A585 Windy Harbour to Skippool Improvement Scheme

7.11 Environmental Statement Changes and Corrections Document

May 2019

APPENDIX C – Updated Figure 9.10 Photomontage at viewpoint location 2, view from residential properties on Breck Road, Photomontage at Viewpoint Location 9, view from Footpath 5-11-FP 2 at Junction with A585 Garstang New Road and Photomontage at viewpoint location 10, view from the B5260 Lodge Lane

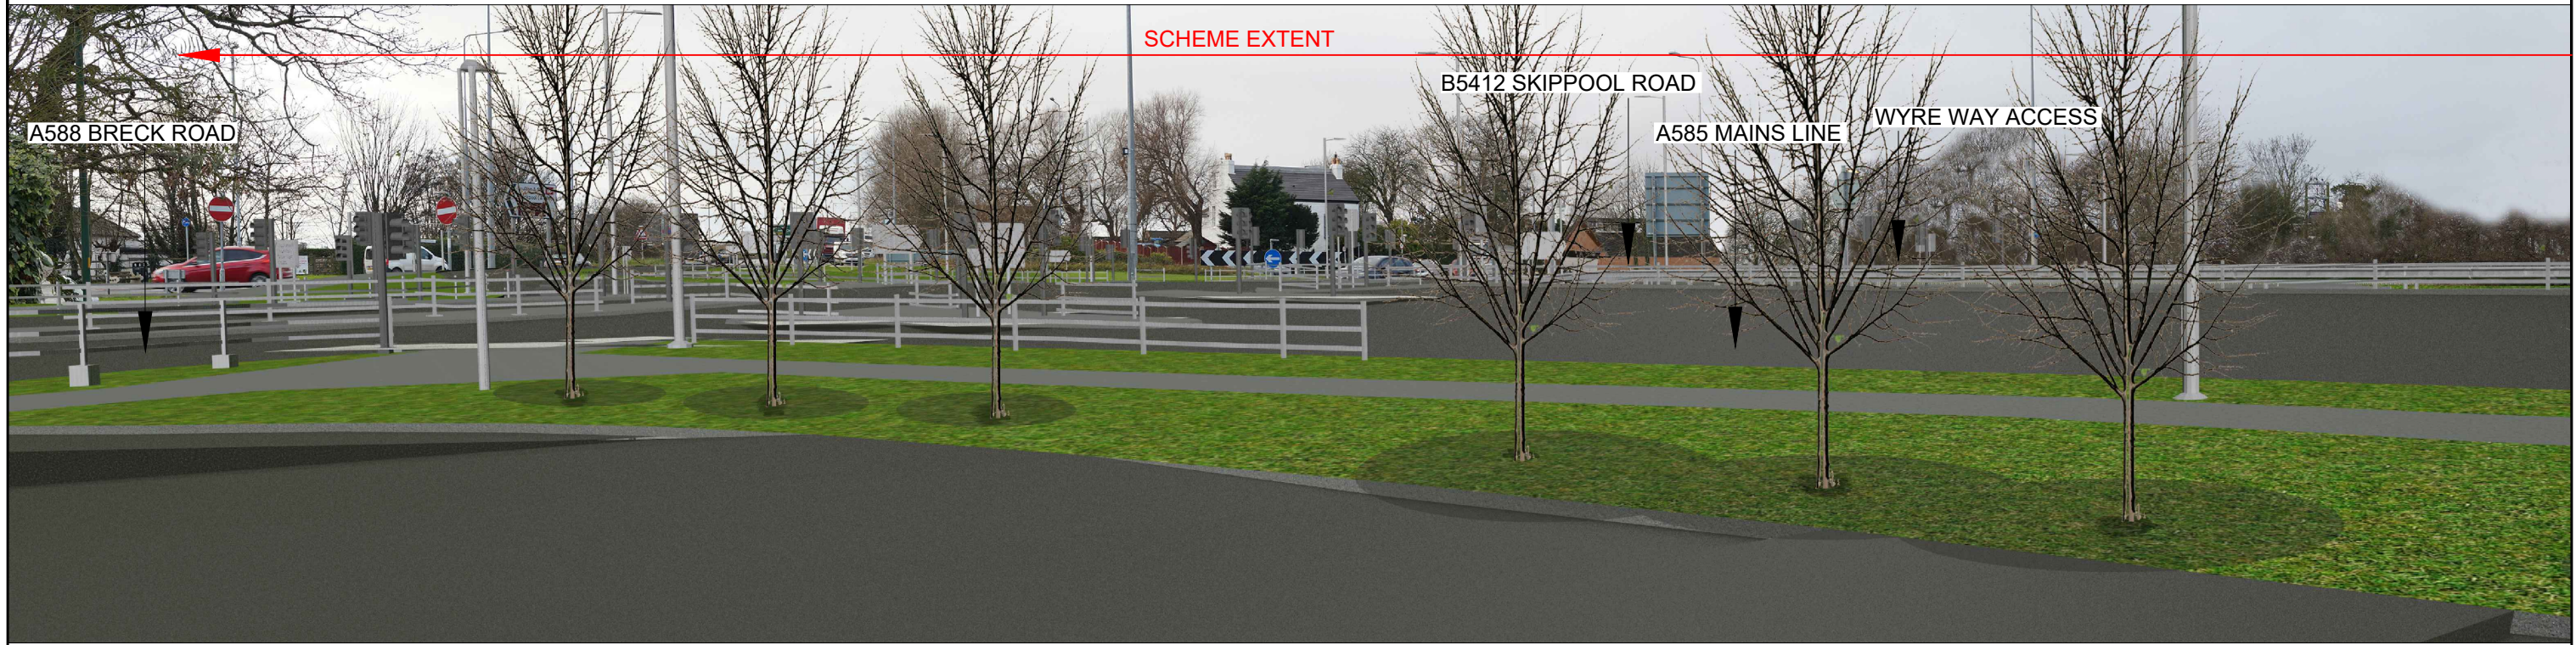
6.9	ES Chapter 9: Landscape	Update to Figure 9.10, Photomontage at viewpoint location 2, view from residential properties on Breck Road provided within Appendix C.	As a result of updates to the Flood Risk Assessment associated with the dwarf wall.

VIEWPOINT 9 PHOTOMONTAGE: YEAR 1

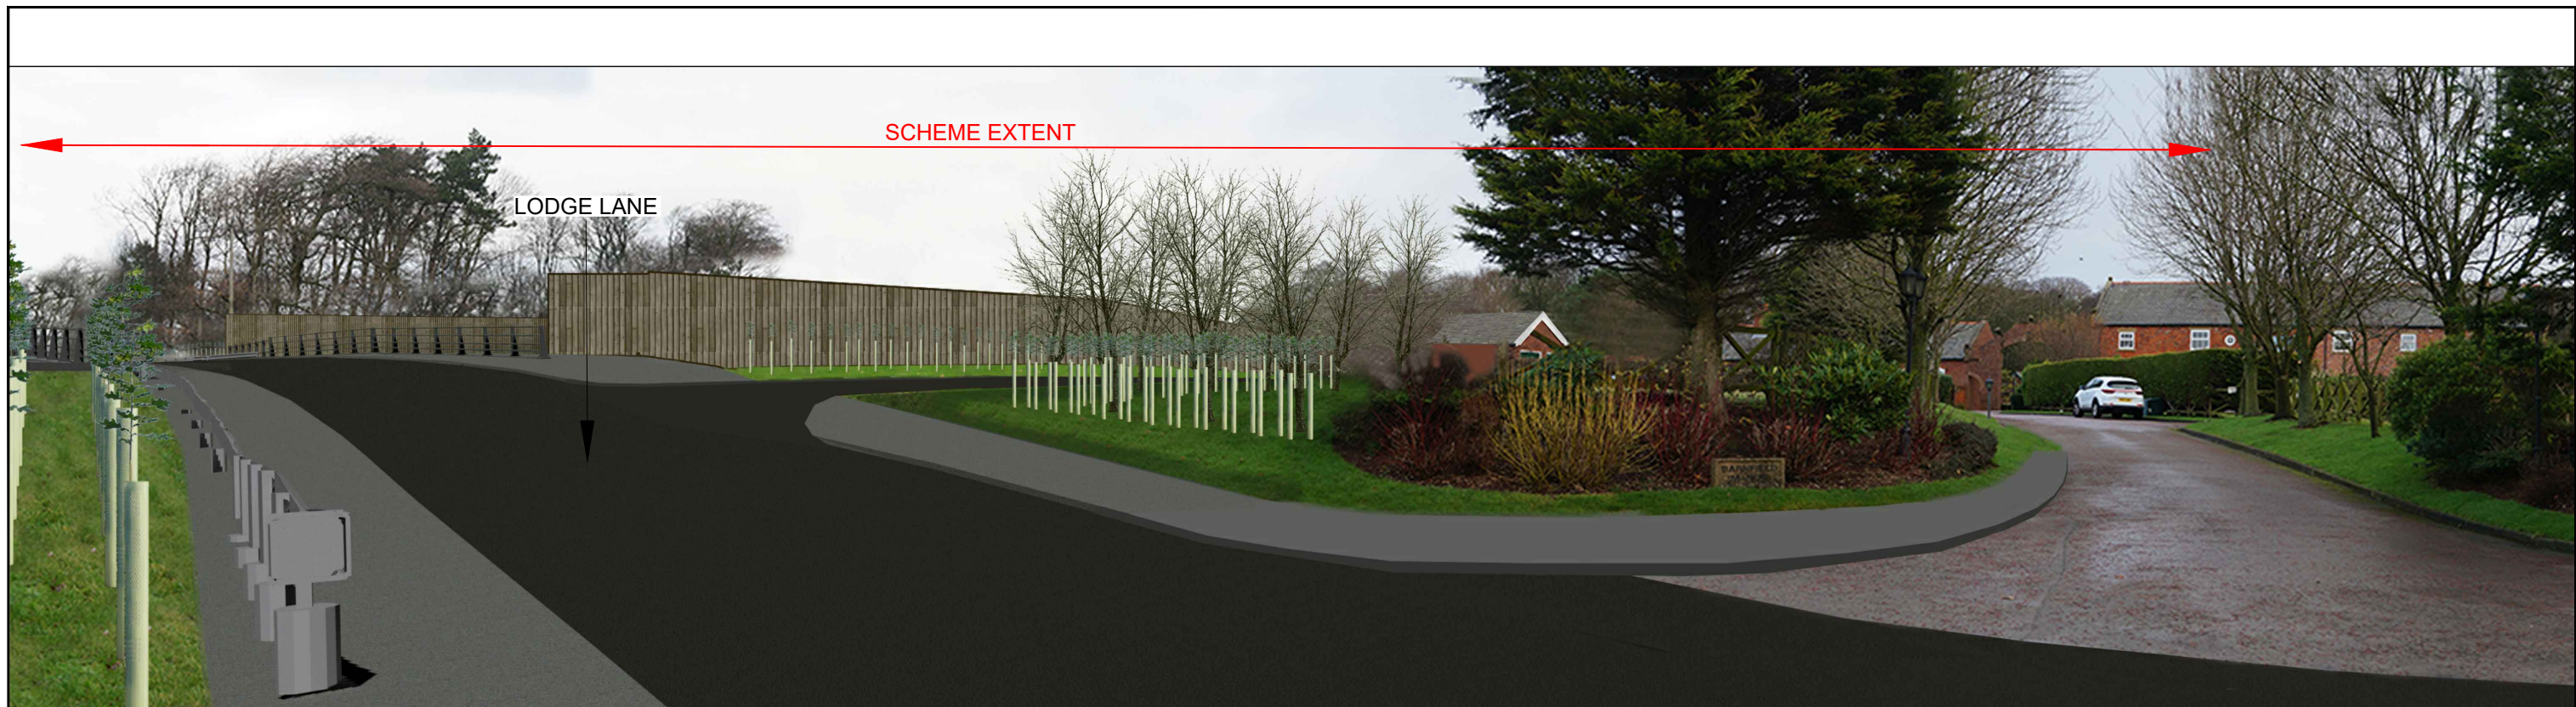
Document Reference Number	Document Name	Amendment Required	Reason												
6.9	ES Chapter 9: Landscape	Update to Figure 9.10, Photomontage at viewpoint location 9, view from the A585 Garstang New Road provided within Appendix C.	Updated to show the additional linear planting adjacent to Grange Footbridge, as a result of request from Fylde Borough Council (document reference TR010035/APP/7.9).												
6.9	ES Chapter 9: Landscape	<p>Update to Table 9-16</p>

Project	A585 WINDY HARBOUR TO SKIPPOOL IMPROVEMENT SCHEME
Drawing Title	ENVIRONMENTAL STATEMENT REGULATION 5(2)(a) PHOTOMONTAGE AT VIEWPOINT LOCATION 10 VIEW FROM THE B5260 LODGE LANE

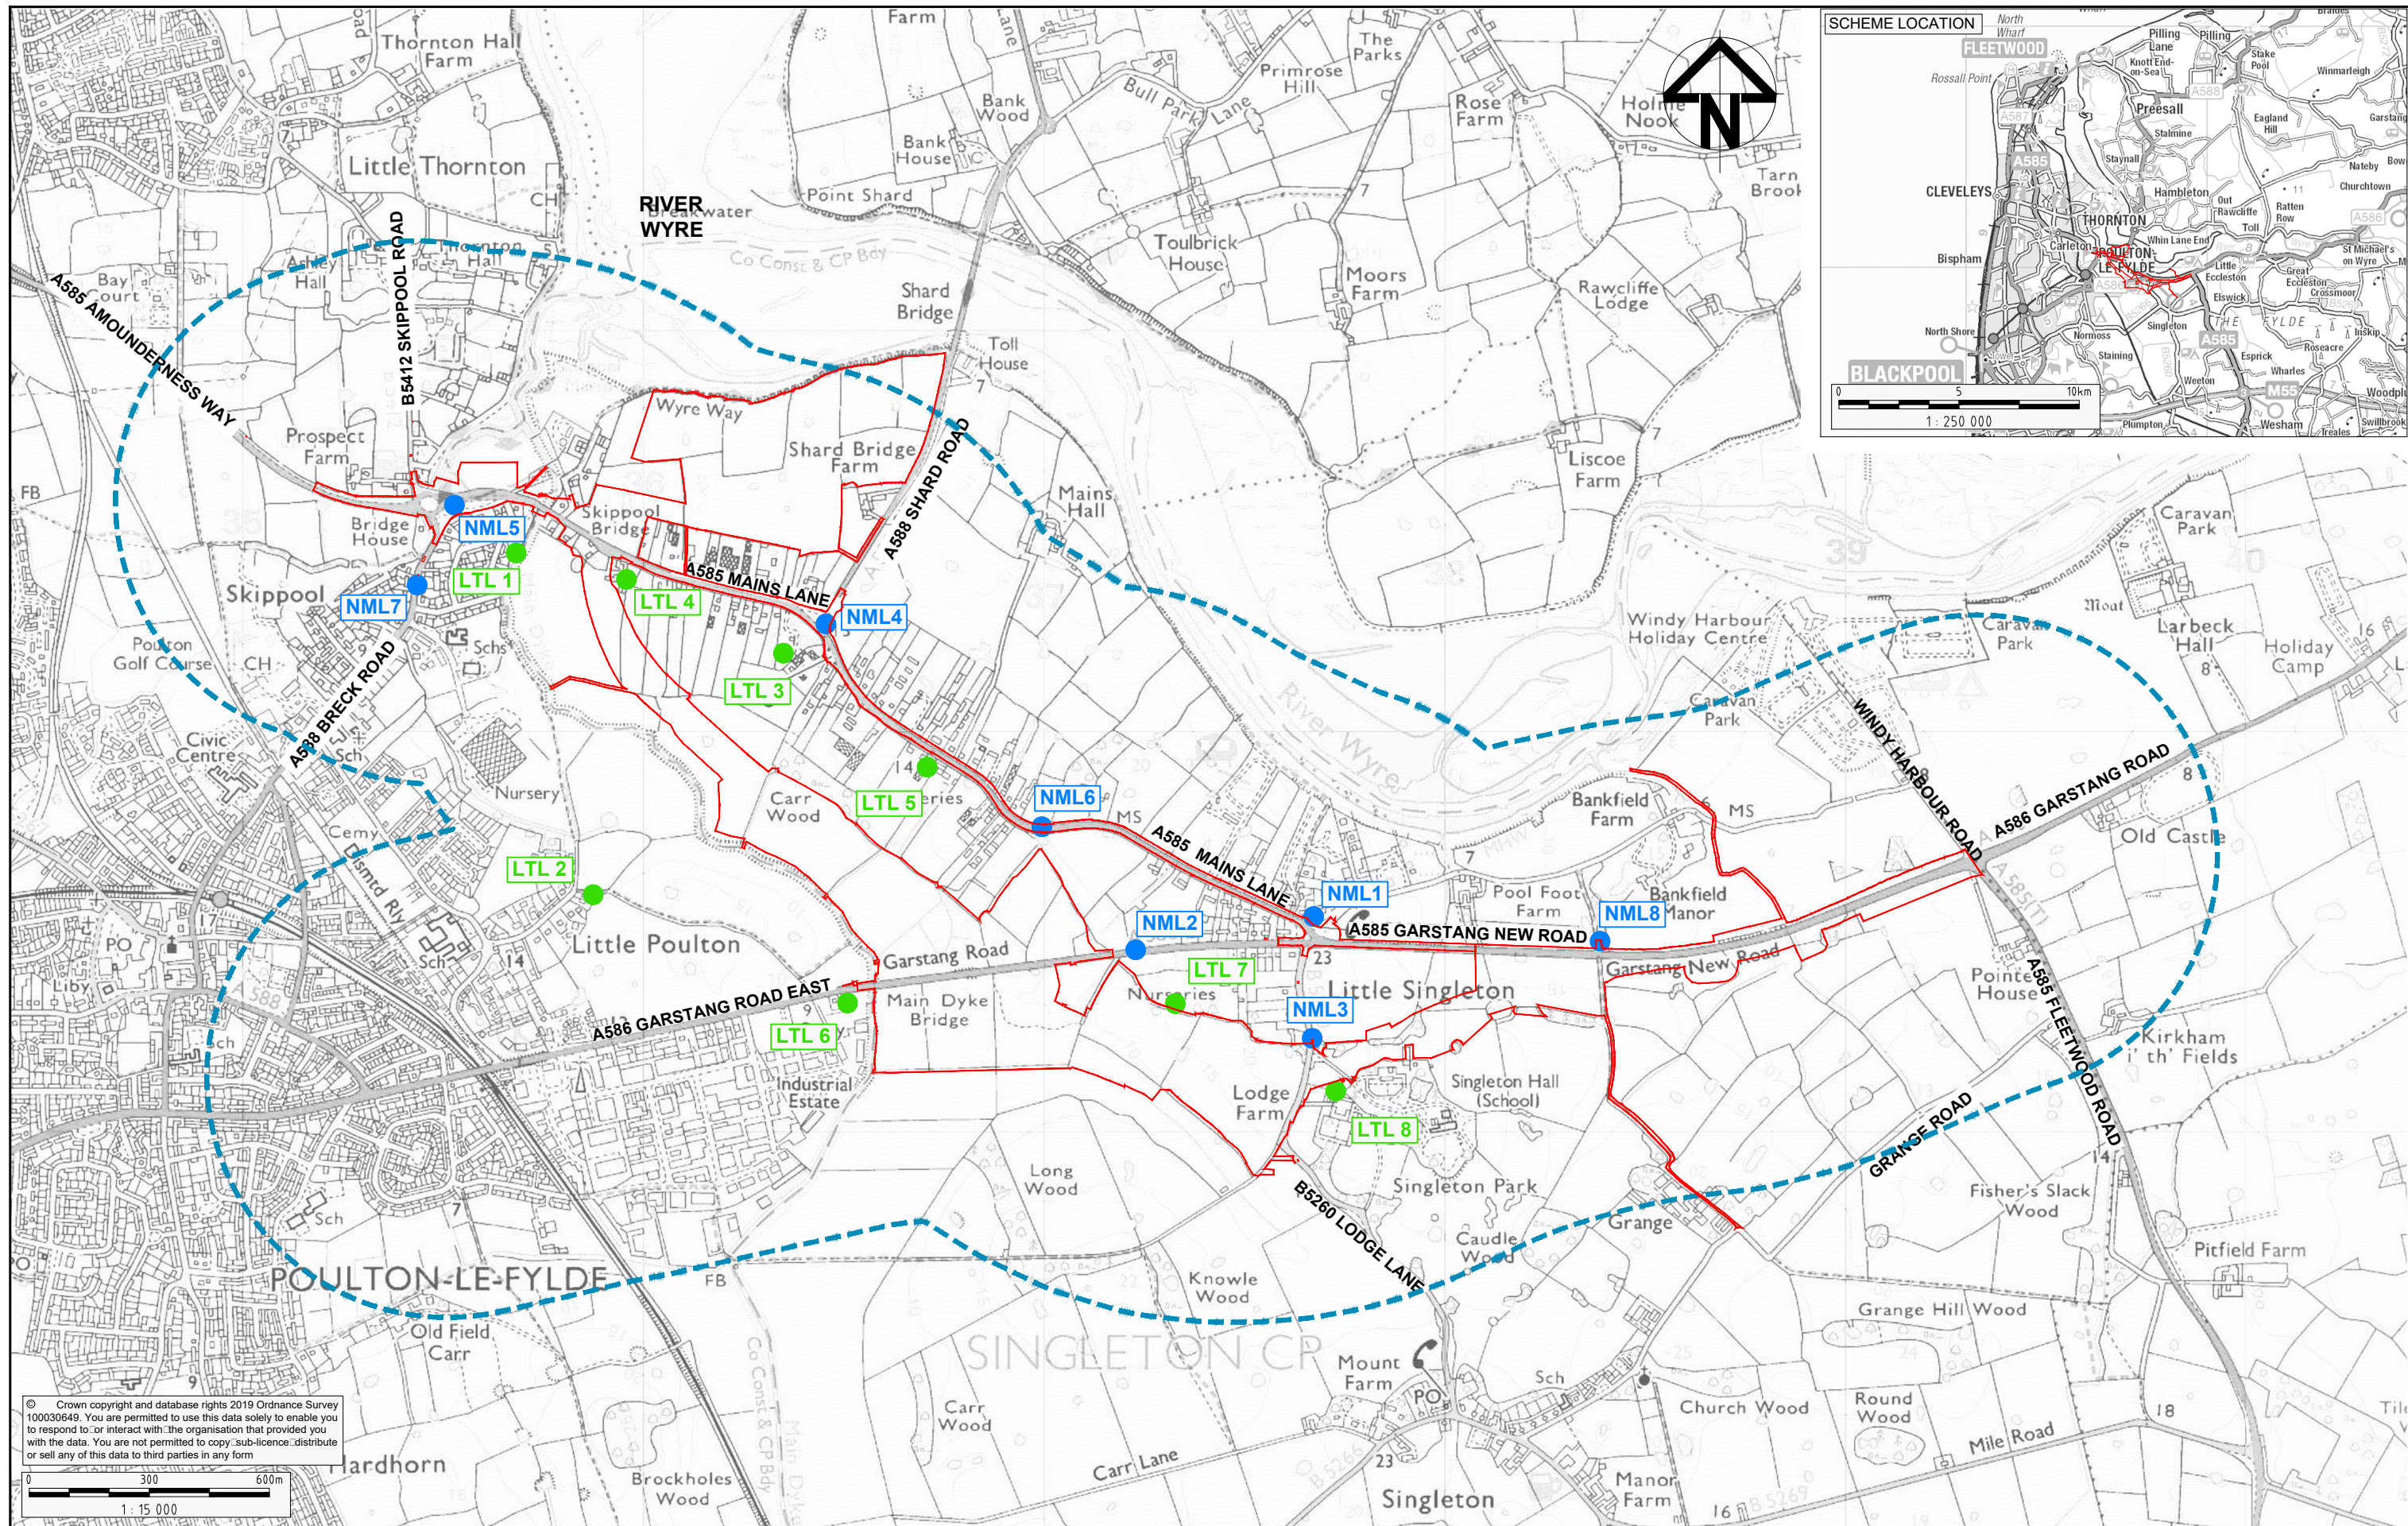
6.9	ES Chapter 9: Landscape	Update to Figure 9.10, Photomontage at viewpoint location 10, view from the B5260 Lodge Lane provided within Appendix C.	Updated to show the 3m high acoustic barrier to the north of the cutting.

Drawing Title
ENVIRONMENTAL STATEMENT REGULATION 5(2)(a) NOISE AND VIBRATION: NOISE MONITORING LOCATIONS WITHIN STUDY AREA

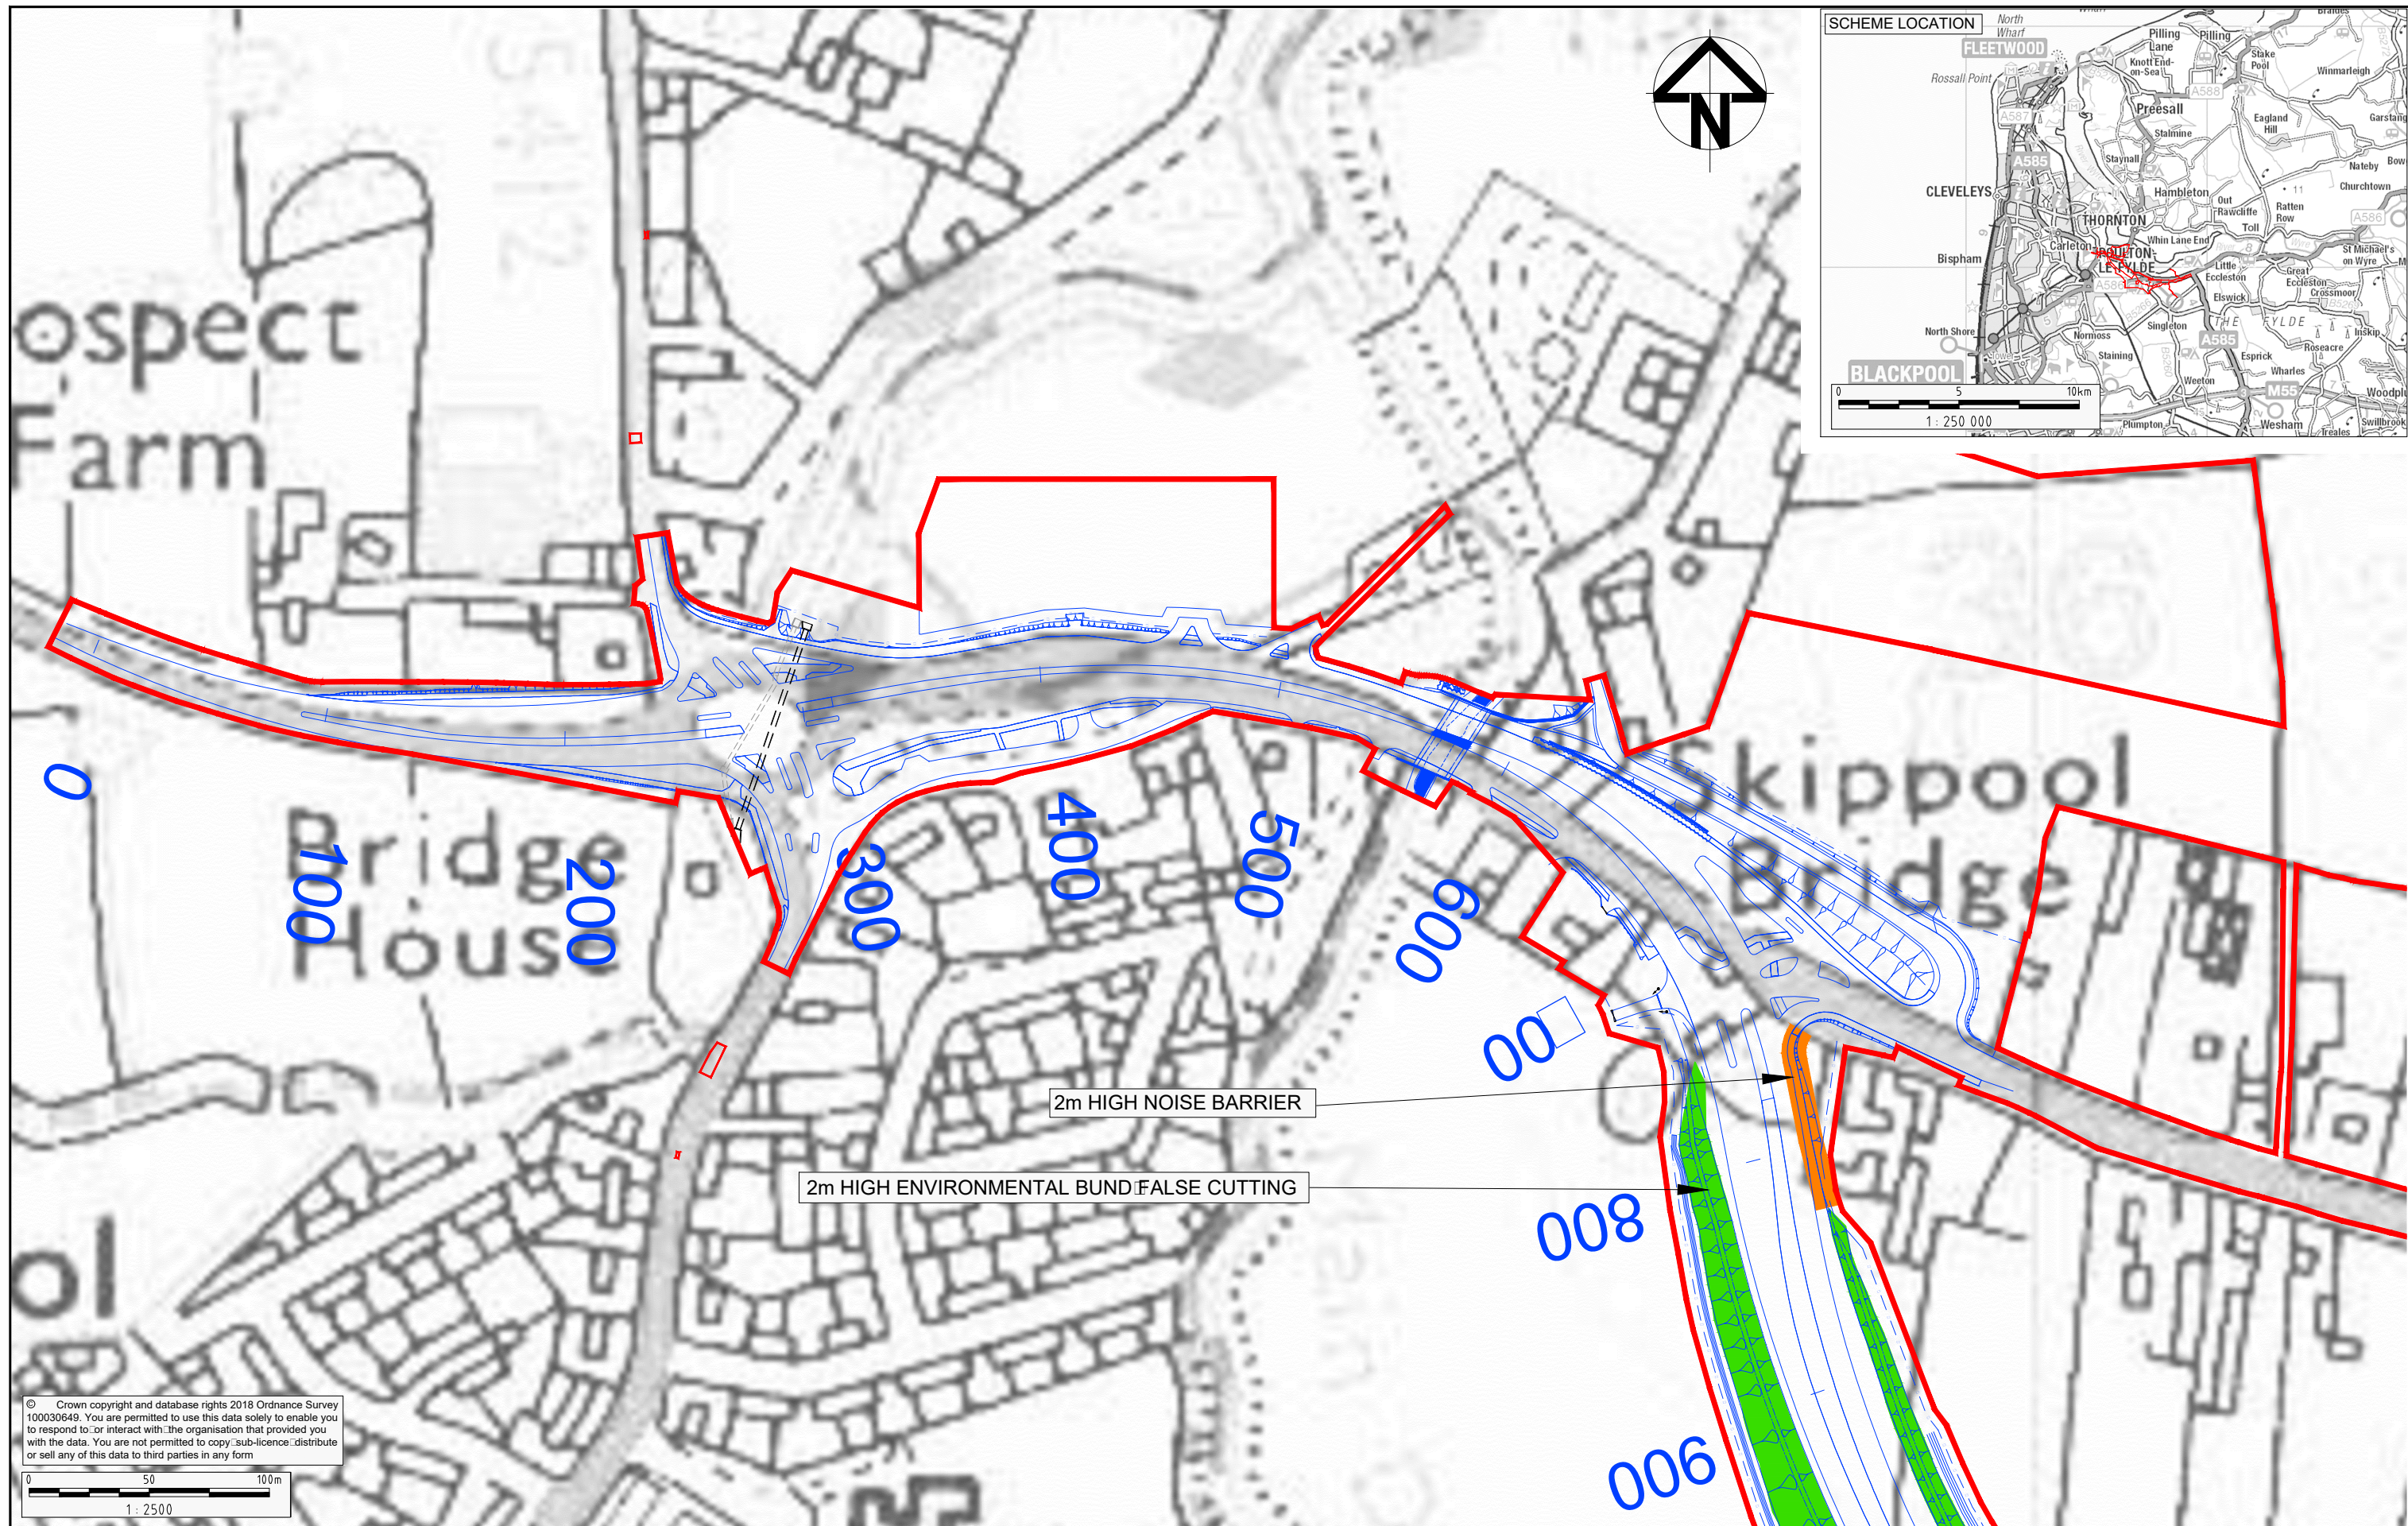
6.11	ES Chapter 11: Noise and Vibration	Update to Figure 11.1: Noise and Vibration – Noise Monitoring within the Study Area presented at Appendix D to show the locations of the eight attended noise surveys.	Requested by the Inspector within the first round of written questions (document reference TR010035/APP/7.10).
